Applies to Revision Level A Boards  
(Revision level not included on silk screen)

Three layout errors exist on the Sol-KBD PC board you received. These errors must be corrected before you check the circuit board and start assembly. How these errors are corrected are described below:

1. Key Pad #55

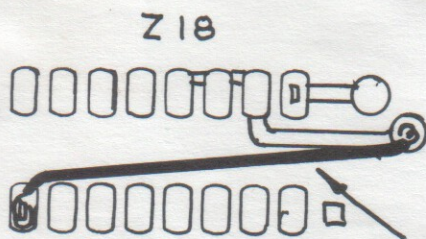
Using a sharp point, cut the bridge between the pad at 55 and the trace above (solder side).

2. U18, Pin 8

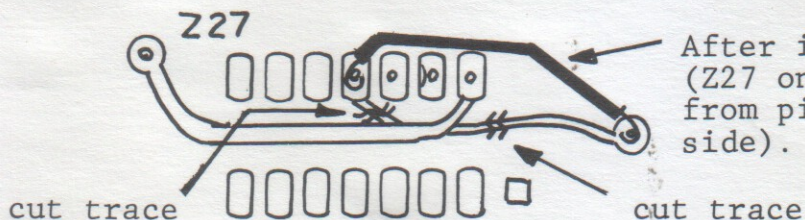
After installation of socket at U18 (Z18 on etch), install jumper wire from pin 8 to ground trace as shown. (Solder side.)
